TO:	Conservation Commission Darryl Luce 79 South Street Wrentham, MA	DATE:	11/11/2022
FROM:	Howard Stein Hudson	HSH PROJECT NO.:	19227.01
SUBJECT:	1139 West Street – Wrentham, MA 02093 20 Hancock Street – Wrentham, MA 02093

Sheldon West

Notice of Intent

Attachment A – USGS Maps

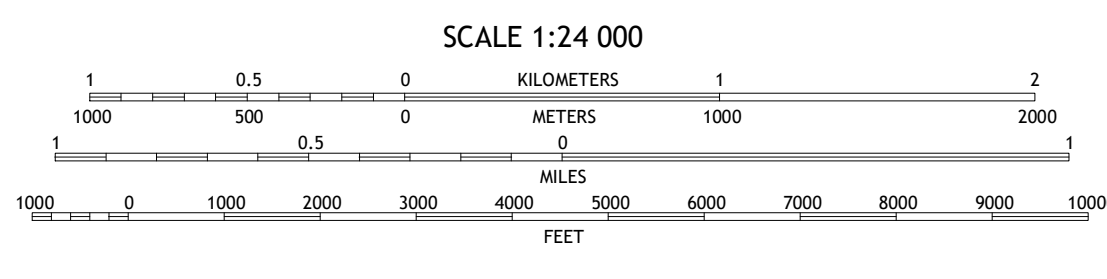
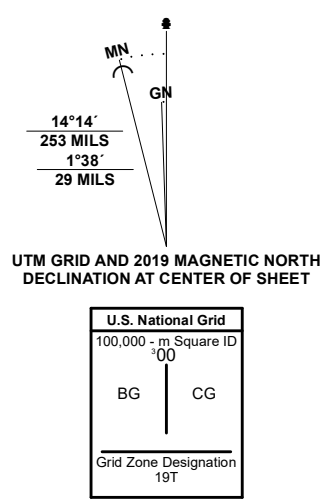
1. 3rd page of cover letter, USGS Topographic Map. USGS maps also show buildings. This map is either from another source or has been edited from the original. Supply the latest USGS map and note any edits done by any party, both additions and any subtractions, to the original USGS topographic map.

HSH: The map that is provided is the original USGS Map on our border from the USGS Mapping system and has only been altered to fit within our border no other edits or alterations were done to the map. The Mass Mapper USGS Map layer shows structures and has been attached to this response as Attachment A, as well as the official USGS Map at a scale of 1:24,000.

CULVERT REMOVAL AND RESTORATION PLAN
SCALE: 1"=20'

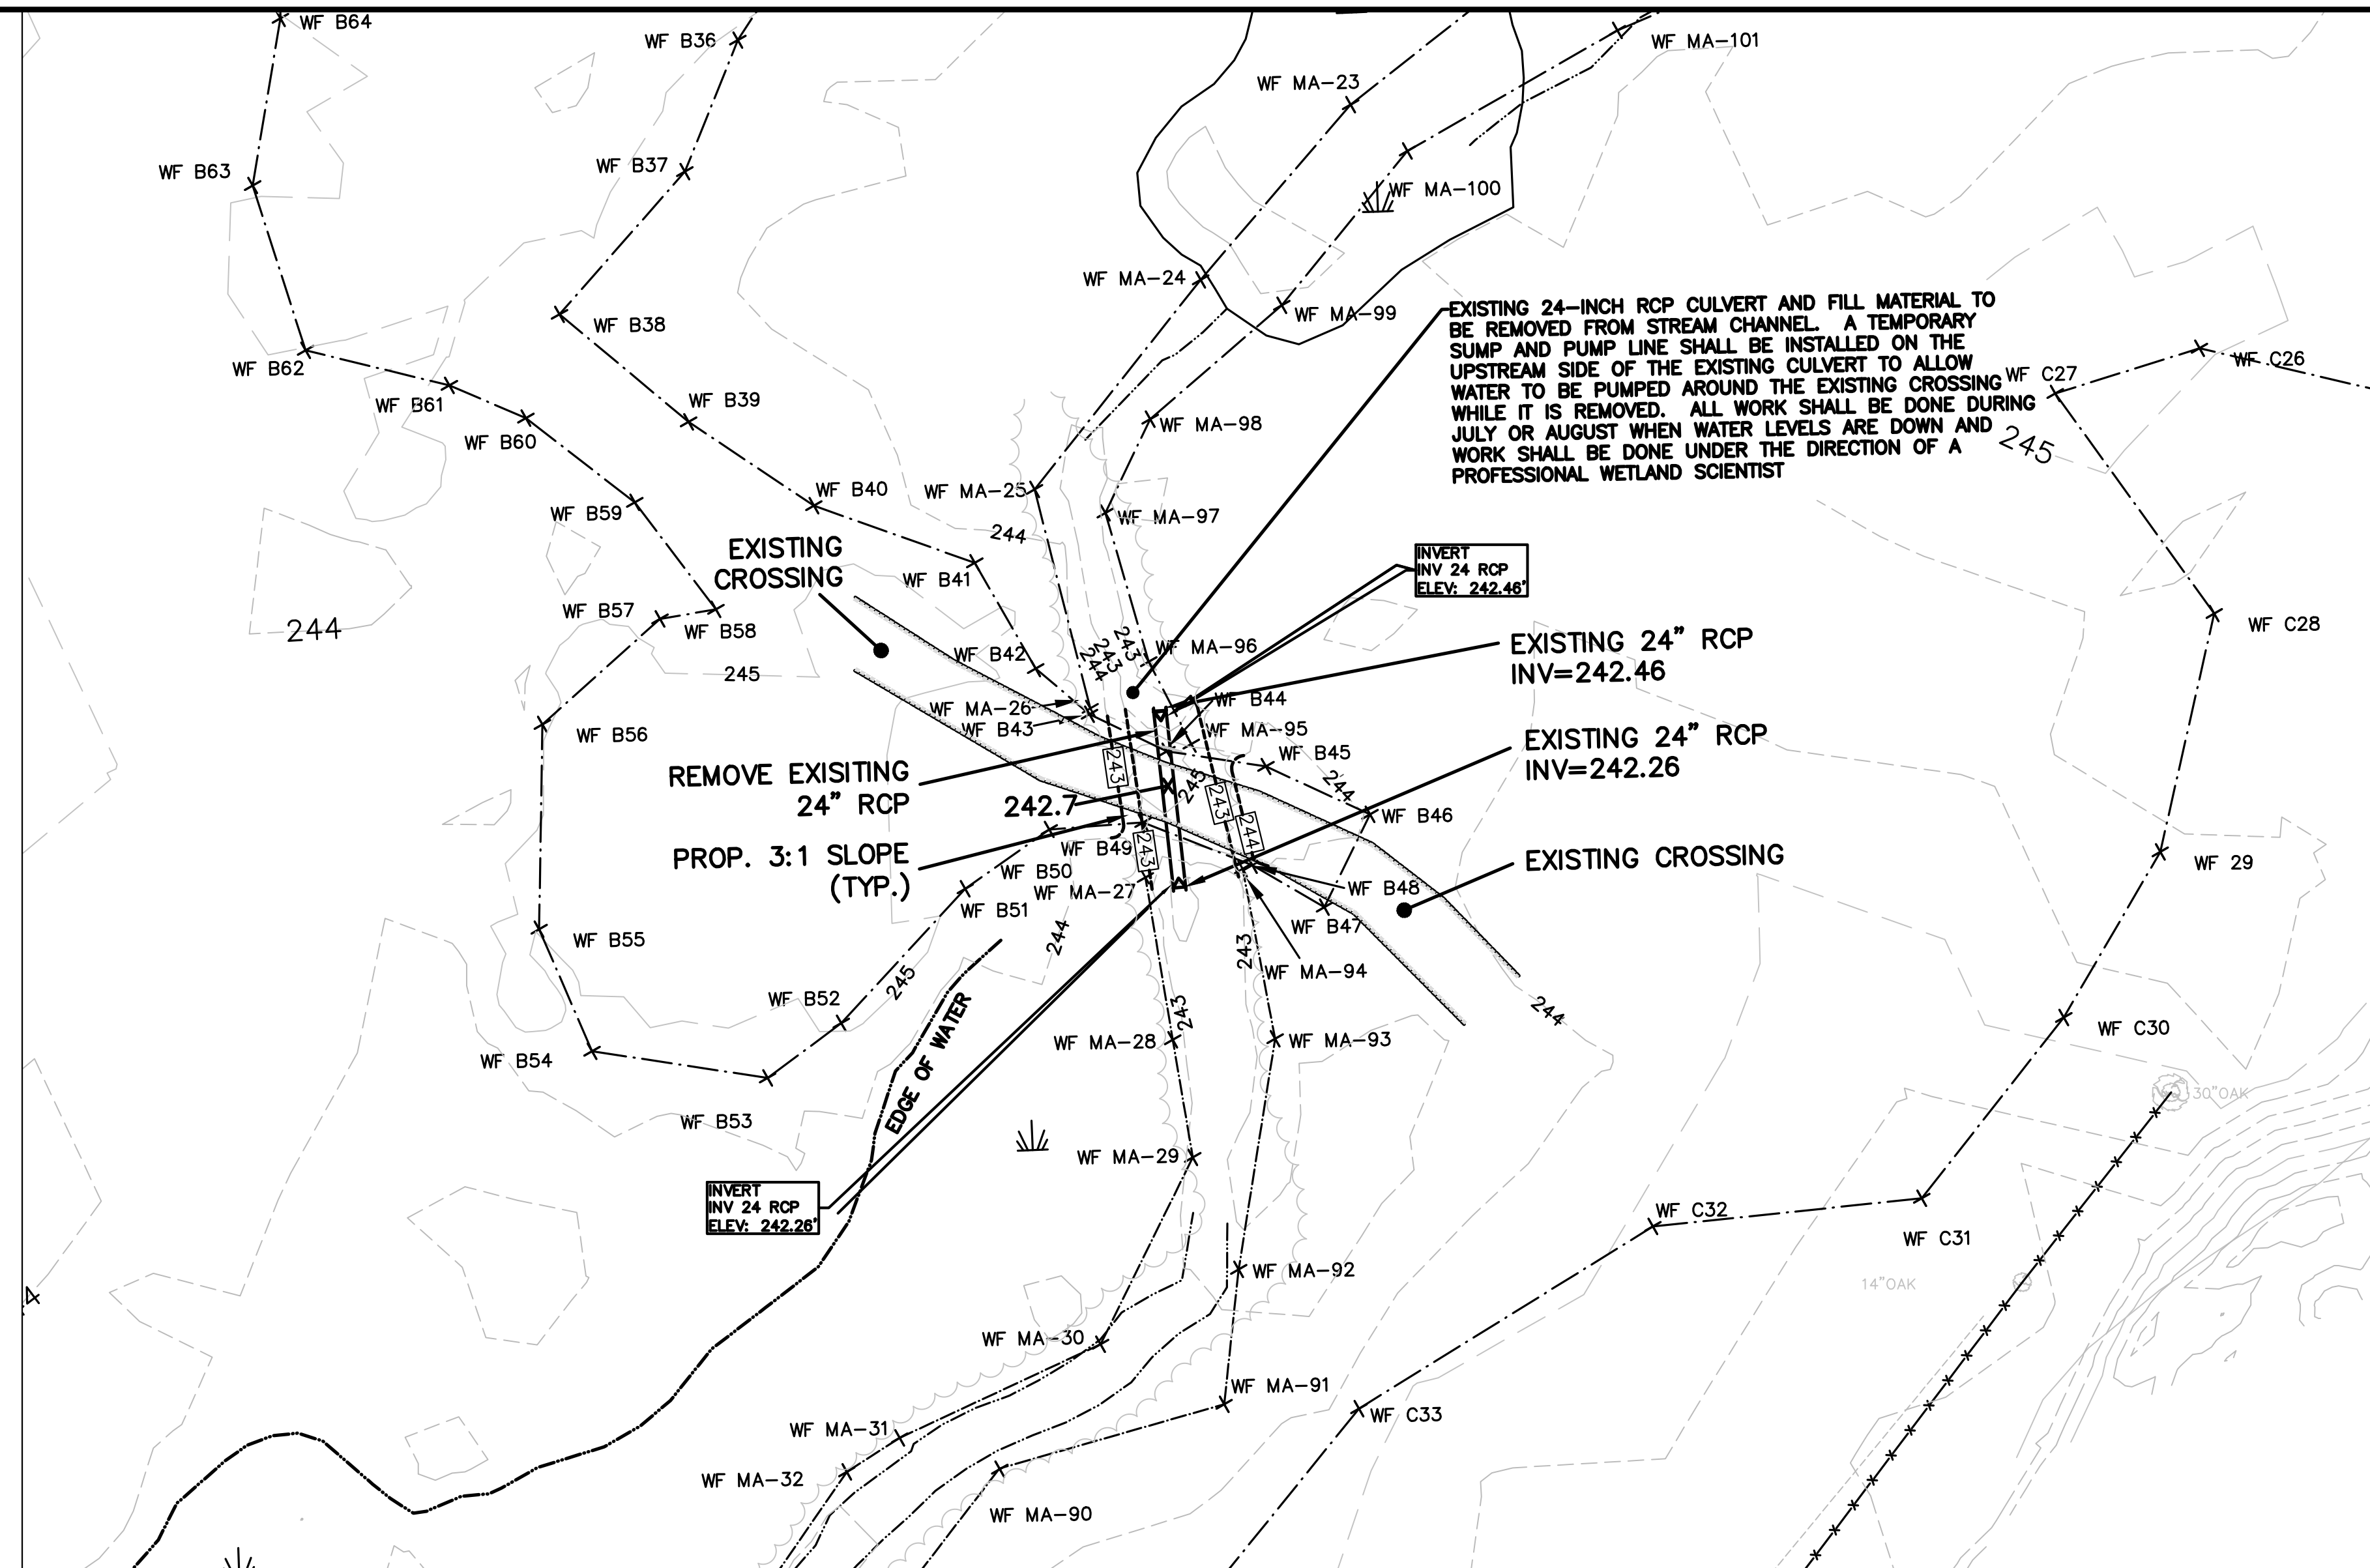
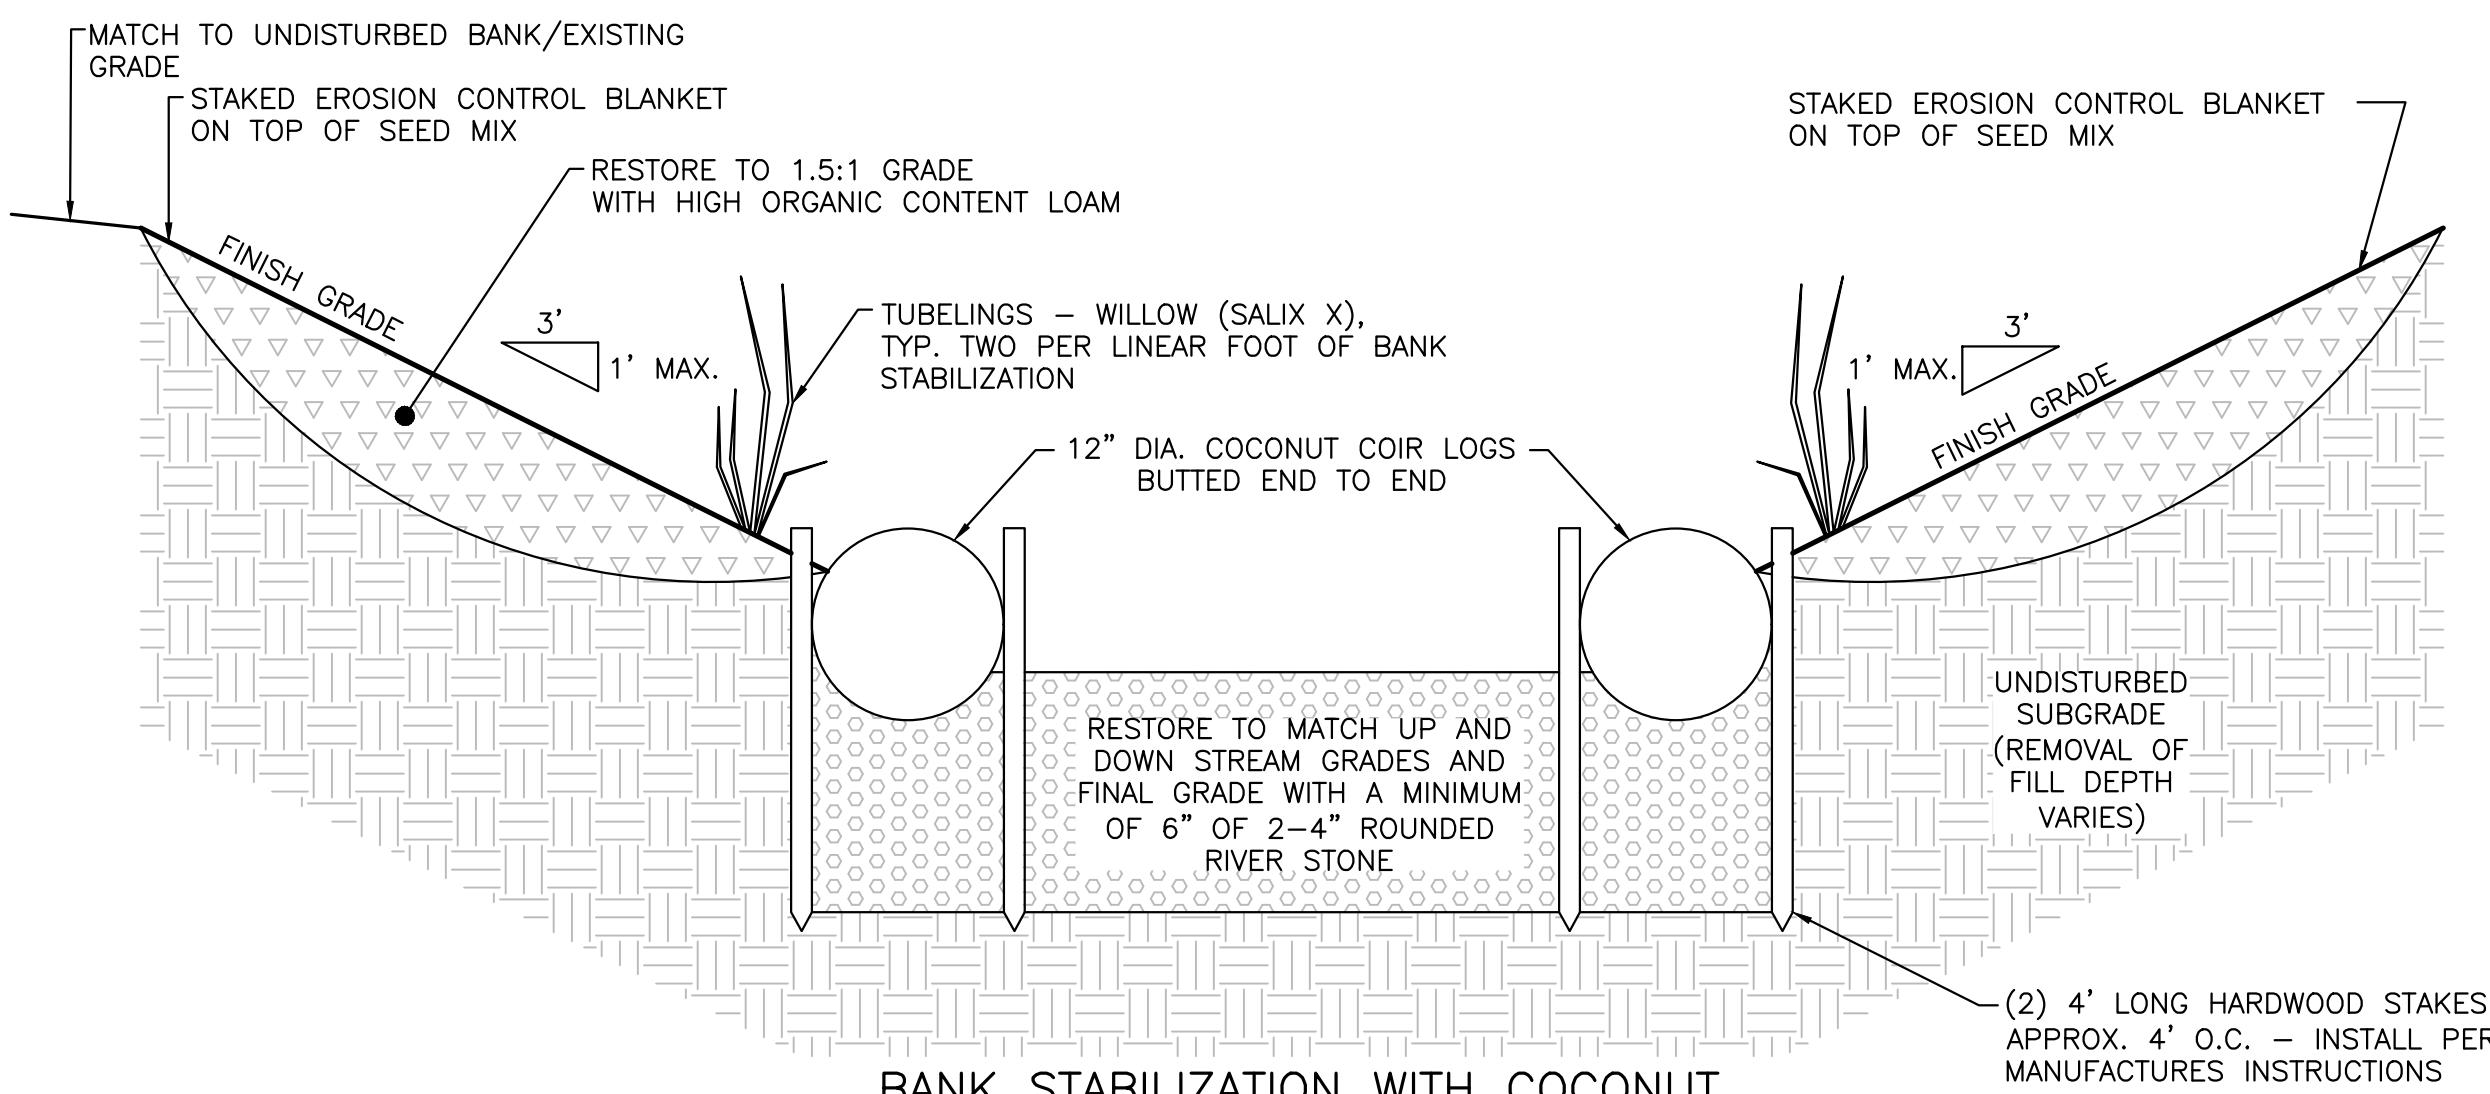
18. Sheet 13 of 31, Layout & Materials Plan, Sheet 2 of 2. This sheet shows a gravel pathway to the “existing trail network...” Provide a detail of this gravel pathway and the construction details. Does this pathway go outside the LOW fence? During prior site visits it appeared that the trail system went onto an abutter’s property. Provide a sheet showing the entire existing trail network that is referred to in this sheet. There was also a stream crossing done with a pipe that was clearly inadequate to handle larger flows as evidenced by overtopping. Since that crossing’s trail leads onto an abutting property, coupled with its flooding issues, it is suggested that this application be amended to include the pipe’s removal and the restoration of the bank in this area.

HSH: A cross-section detail of the gravel pathway has been added to the plans on detail sheet 1 of 8. The limit of work is shown on the outside of the extension of the gravel path we are proposing. Outside of the limit of work the path will remain in its existing condition. If a trail is on any other property it will remain in its existing condition. The entire trail network was not surveyed as its location and condition is not within the scope of our project, we are creating an access point to the existing trail as requested previously by this commission. Per request of the commission the culvert pipe at the stream crossing is being proposed to be removed, regraded and planted to restore the stream in that area. Attached as Attachment C here is an exhibit with the proposed removal of the culvert and replanting of the area.
